# 1101 WESTERN AVE

Early Design Guidance #2  
SDCI # 3033606-EG  
July 9, 2019

SUMMARY OF BOARD COMMENTS: EDG #1

# WESTERN AVE SECTIONS

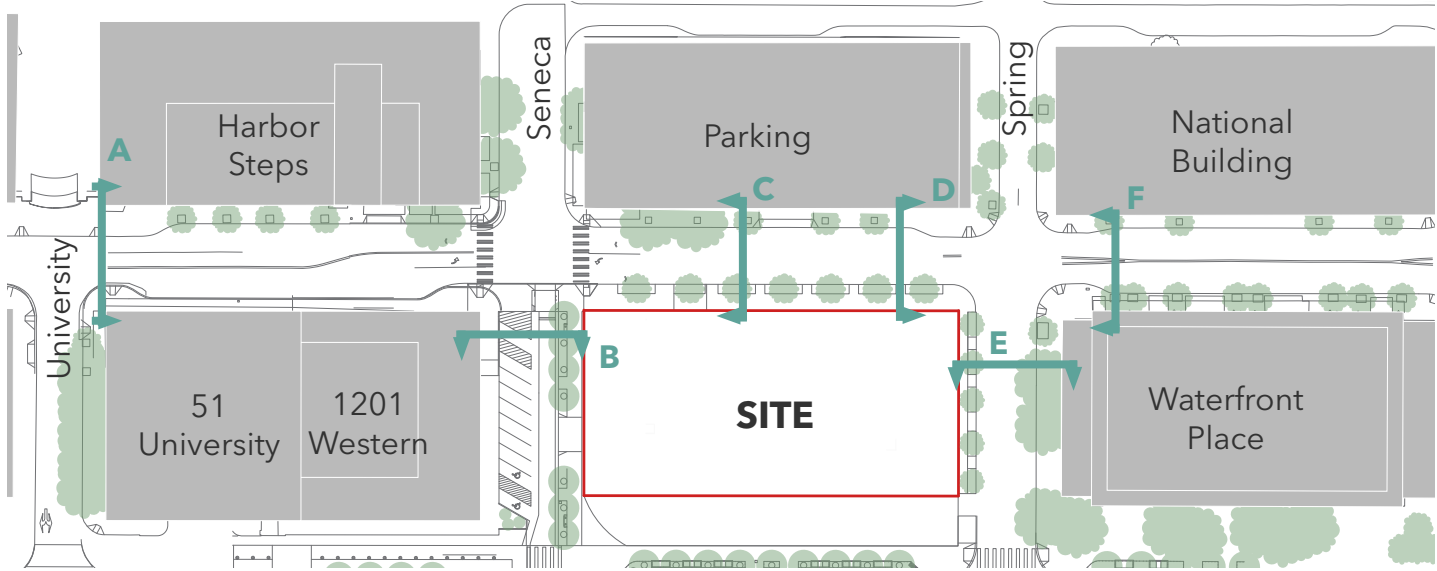
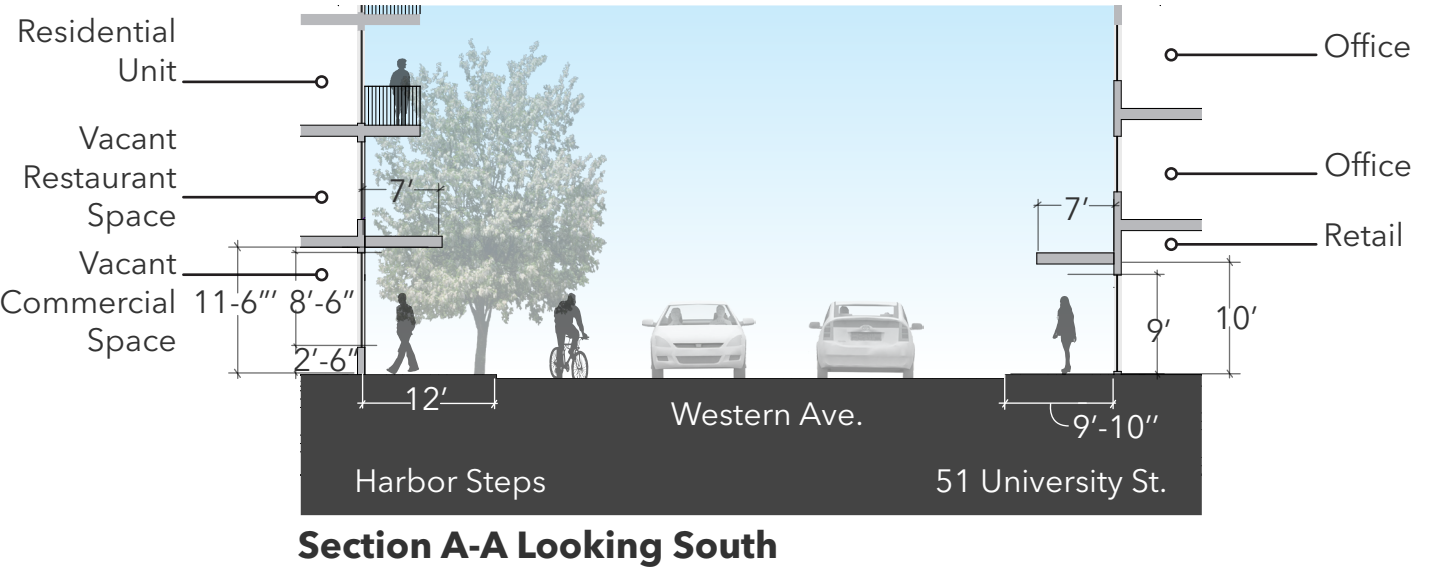
At the EDG #1 Meeting the Board requested sections through Western Ave and transverse streets to more closely study the relationship of ground level floor heights, canopies and streetscape character relative to existing building.

The sections demonstrate the proposed building matches ground level floor height and weather protection while also enhancing the public realm through increasingly active ground level programming as well as a generous sidewalk at Western asserting pedestrian priorities.
